JOB: COLLECTION OF MATERIALS FROM BHEL/CLIENT'S STORES/STORAGE YARD, TRANSPORTATION TO SITE, **ERECTION , TESTING & COMMISSIONING, TRIAL OPERATION AND HANDING OVER OF BOILER AND ITS AUXILIARIES** INCLUDING ESP, AIR PREHEATERS, DUCTS AND DAMPERS, FANS, COAL MILLS, FUEL PIPING, BOILER INTEGRAL PIPING, POWER CYCLE PIPING, CHEMICAL DOZING SYSTEM, LINING & INSULATION, FINAL PAINTING (INCLUDING SUPPLY OF PAINT) ETC FOR **UNIT-3 & 4 OF 2X660 MW NTPC MOUDA PROJECT** AT MOUDA, DISTRICT NAGPUR IN MAHARASHTRA STATE

SI No	Tender Specification Number	Unit Number & Project
1	BHE/PW/PUR/MADT2 - BLR(Vertical Pkg) U 3/1088	600 MW Boiler Vertical Pkg of Unit 3
2	BHE/PW/PUR/MADT2 - BLR(Vertical Pkg) U 4/1089	600 MW Boiler Vertical Pkg of Unit 4

This letter is hosted as file titled "Corrigendum-03 (Clarification-1091)" against NIT-13461 in BHEL web page (www.bhel.com→Tender Notifications → View Corrigendum).

NEUTRALISING PIT OF SIZE 16M X 25 M X 3M

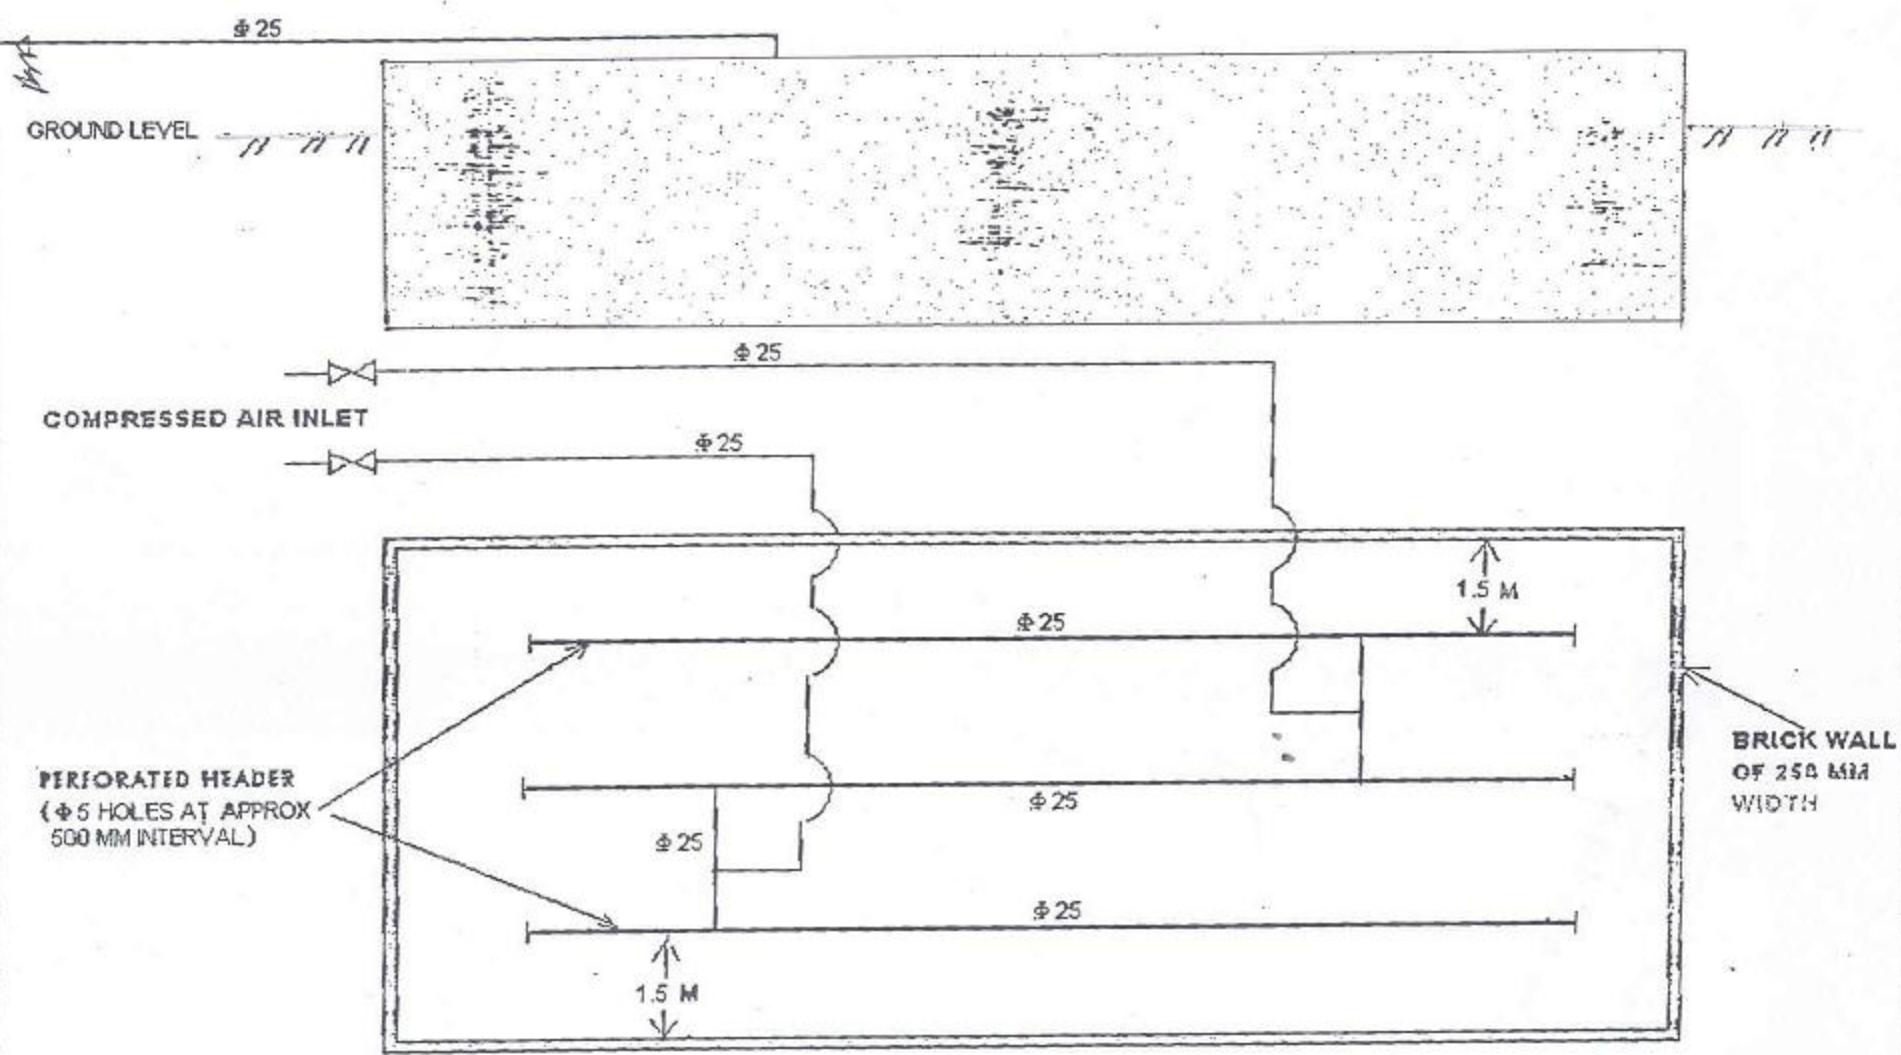
8	Cl. No. 4.2.2.9 on page 12 of Vol IC 'SCC'	As per clause 'the area and infrastructure development Shall be responsibility of contractor' Pl, confirm the approx. area which the contractor has to back fill & consolidate so that proper costing could be done.	The approaches for placement of contractors scope cranes in Boiler & ESP is considered for area development. However the clause number 4.2.2.9 on page 12 of SCC shall prevail.
09	Clause 3.3.0, 3.3.1a, at page no. 37 Chapter III of Vol IA 'TCC',	As per specification Water supply for construction purpose is in bidder scope. Please confirm whether DM water for hydro test, chemical cleaning & flushing provided by BHEL (or) Not.	DM water for hydro test shall be provided by BHEL.
10	Clause No 13.2, Para 2 Chapter III of Vol IA TCC	As per tender Neutralization pit for EDTA cleaning is to be made by the contractor. What is the size of pit? Any kind of flooring is required or not? What will be the volume of effluent to be disposed?	Sample drawing of 1200 m ³ of Neutralisation PIT is attached here with as (Annexure I to Corrigendum III). The requirement for 660 MW Unit would be 1500 m ³ (25 mX 30mX 2m)

1. The neutralizing pit to be made of Bricks and cemented/plastered from inside with bituminous paint.
2. The length of the trench may be extended to the suitable point up to waste disposal.
3. All dimensions are in meters.
4. The W (width) and L(Length) dimensions can be altered keeping the area (20 x 30 x 2 meter = 1200 Sq. Meter) constant depending upon space at site .
5. 2 Nos. of dewatering pump, Suction head (-) 3 meter ,Discharge head 5 to 8 mtrs. Flow 50 to 60 Cubic meter .
